**Document ID:** IK0900114

**Title:** Upper Radiator (Inlet) Hose Saddle Clamp Causing Leaks

**Applies To:** DuraStars and CE Buses with Cummins ISB

**Figure 1: Old and new design of saddle clamp**

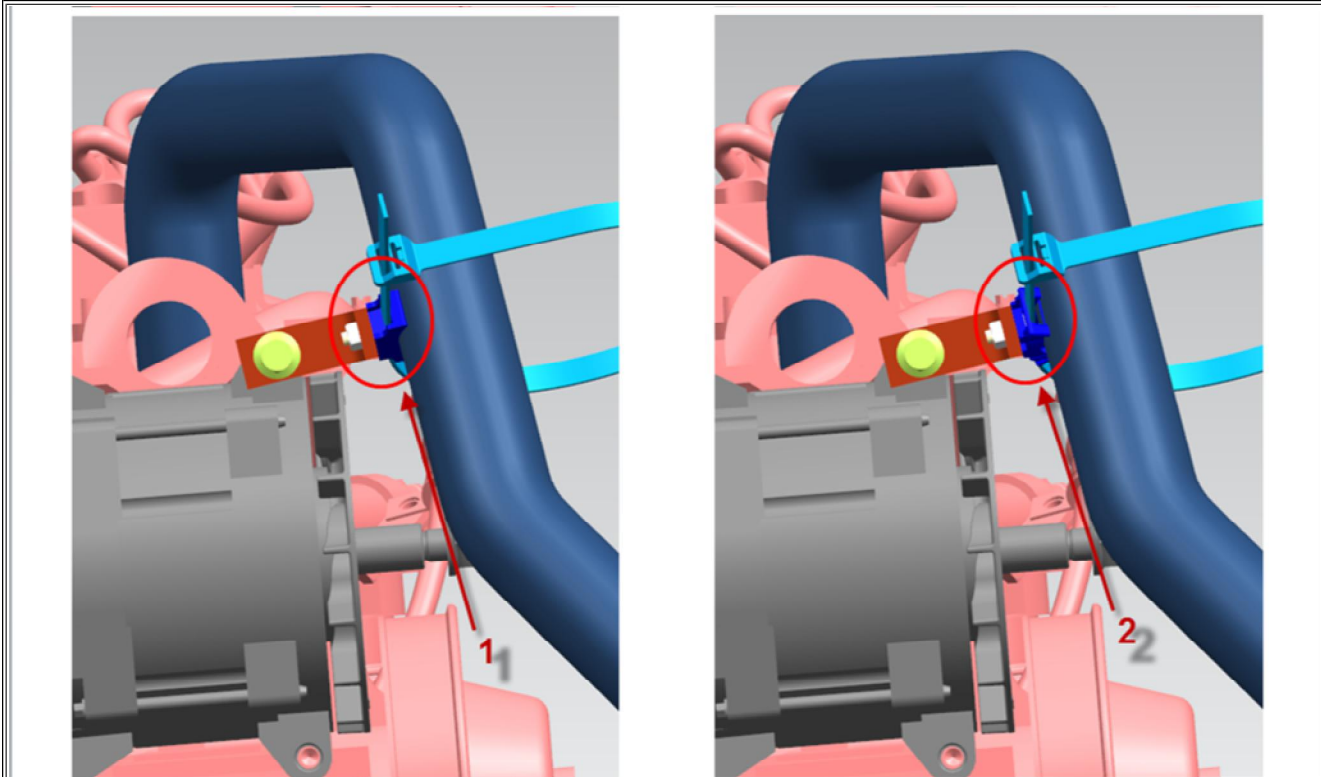
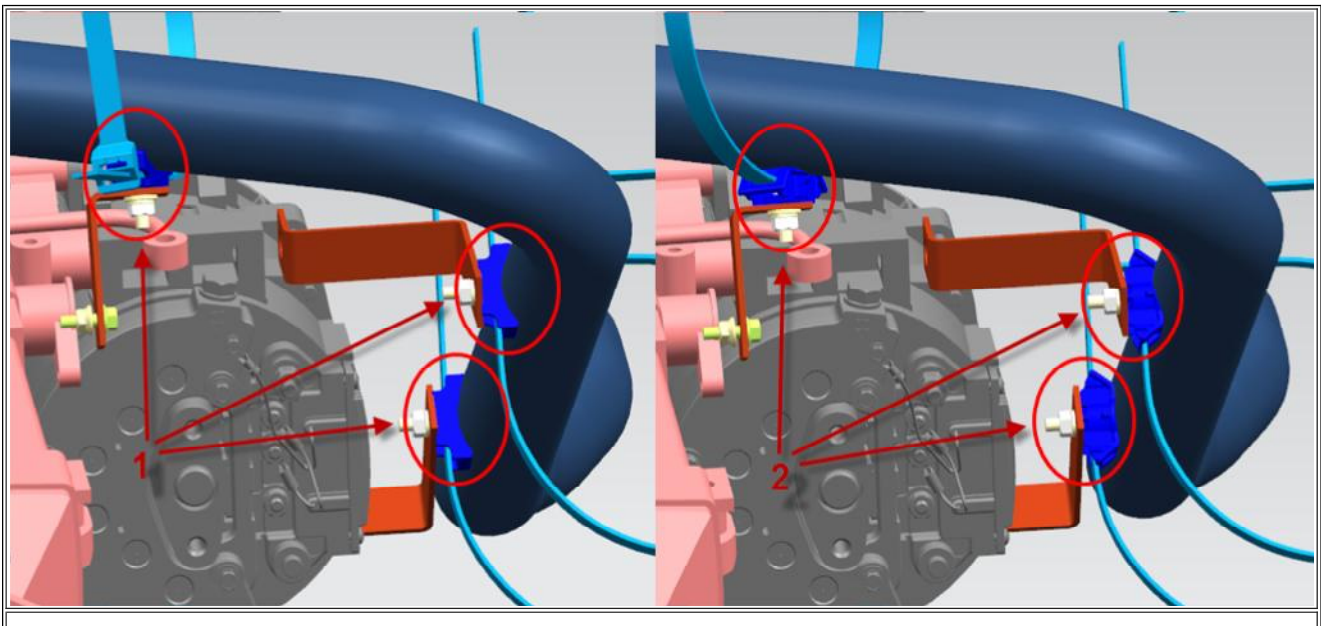
Visually inspect for rubbing/hose damage. See **Figures 1 and 2** for comparison of old and new saddle clamp design. If the hose is punctured and the saddle clamps are the old design, replace hose and replace saddle clamps with new design.

- Item 1: Old design - P/N 2041341C1
- Item 2: New design - P/N 4039319C1

**Figure 2: Old and new design of saddle clamp**

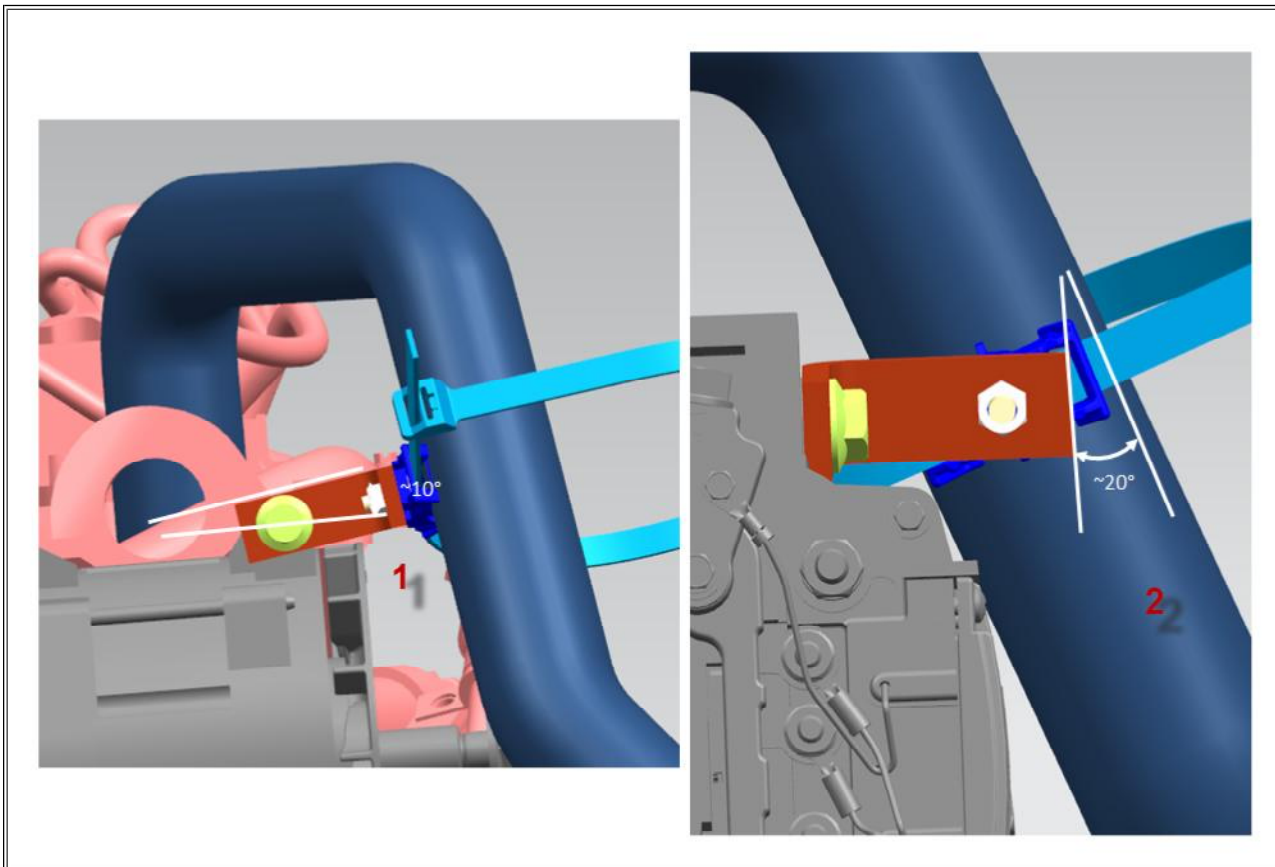
Item 1: Old design - P/N 2041341C1  
Item 2: New design - P/N 4039319C1

Figure 6: Unit assembled to specifications

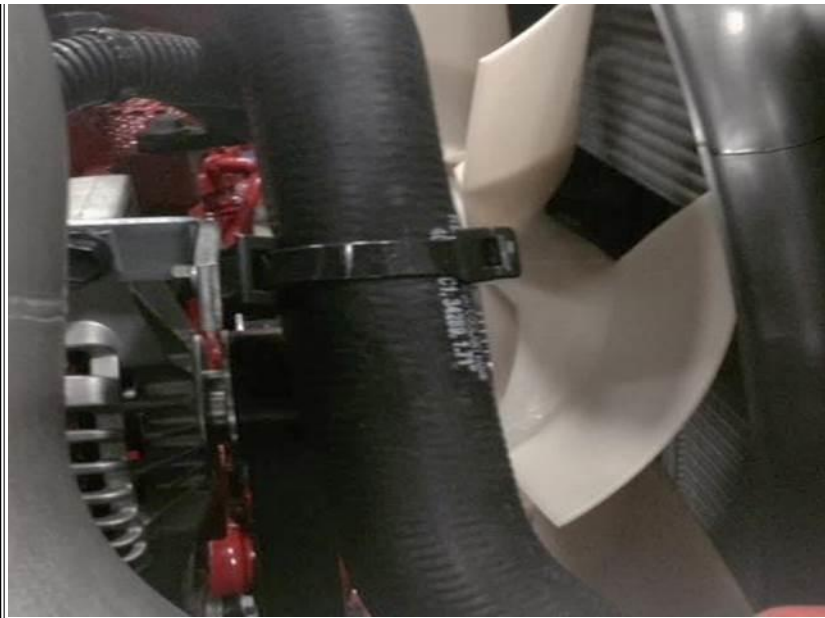
1. Remove old zip straps and saddle clamps.
2. Replace upper radiator hose.
3. Install new saddle clamp and zip strap, as shown in **Figure 3**. The angle of both the extension bracket and the saddle clamp in relation to the bracket must be correct, otherwise rubbing can occur.

Item 1: Extension bracket angled up from parallel  $\sim 10^\circ$ .  
Item 2: Saddle clamp angled  $\sim 20^\circ$  up from parallel. Axis of saddle should align with axis of hose.
